April 30, 2003

*Cooling Water
Alternatives*

*ESSA review
DNC Response
ESSA response*

MILLSTONE POWER STATION
 COOLING-WATER SYSTEM TECHNOLOGY STUDY
 RESPONSE TO ESSA TECHNOLOGIES LTD. REPORT DATED JANUARY
 21, 2003 AND CONNECTICUT DEPARTMENT OF ENVIRONMENTAL
 PROTECTION LETTER OF FEBRUARY 10, 2003

Figure 2: Parallel Offshore Barrier, Proposed DNC design
(colored by larvae concentration)

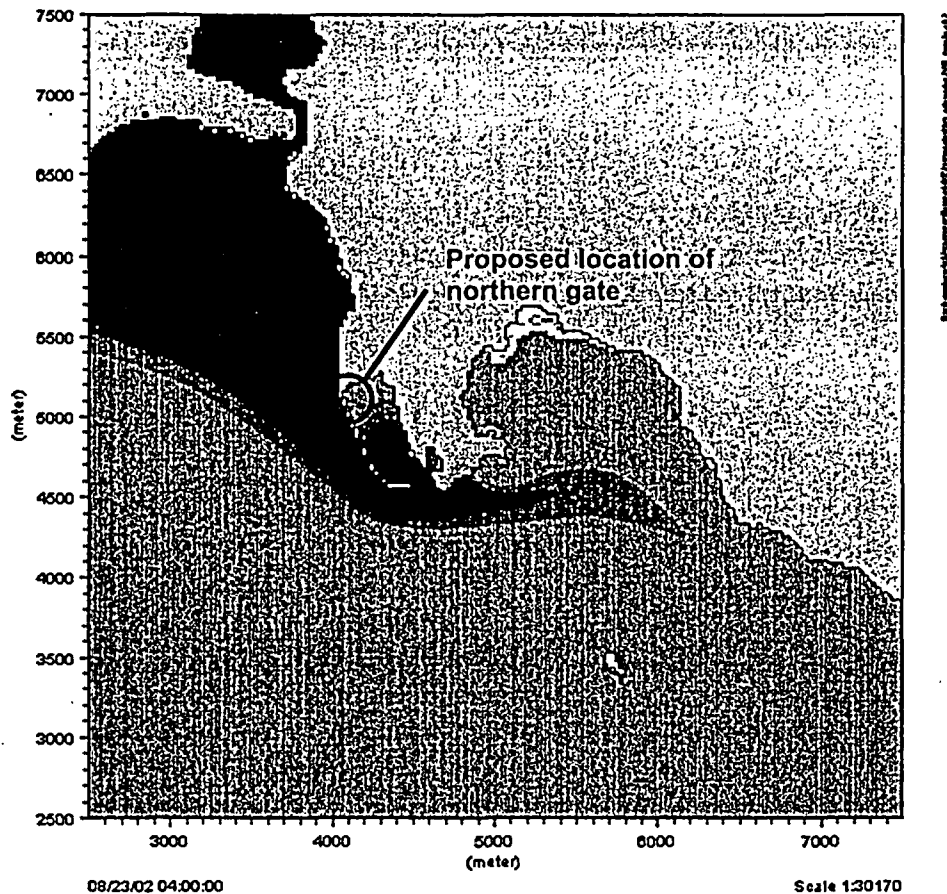
ESSA Comment: "A third possible strategy to mitigate recirculation of heated discharge with the shoreline barrier that could be simulated with the model is the effect of the discharge from the quarry being relocated to the Northeast side of the quarry into the bay that is opposite to the intakes. Discharging the heated effluent to the Northeast side of the quarry headland may be sufficiently far from the intakes to prevent recirculation of the discharge during a flood tide."

Response: This modification could be studied with the numerical model (at least in a rudimentary way). However, discharging water into the bay that is opposite the intakes would heat the water of the embayment substantially. With the current design, the discharge at the end of Millstone Point releases heated water into a relatively deep area in Niantic Bay where tidal flows are vigorous (Figure 1 – deep water areas at the end of Millstone Point) this helps to
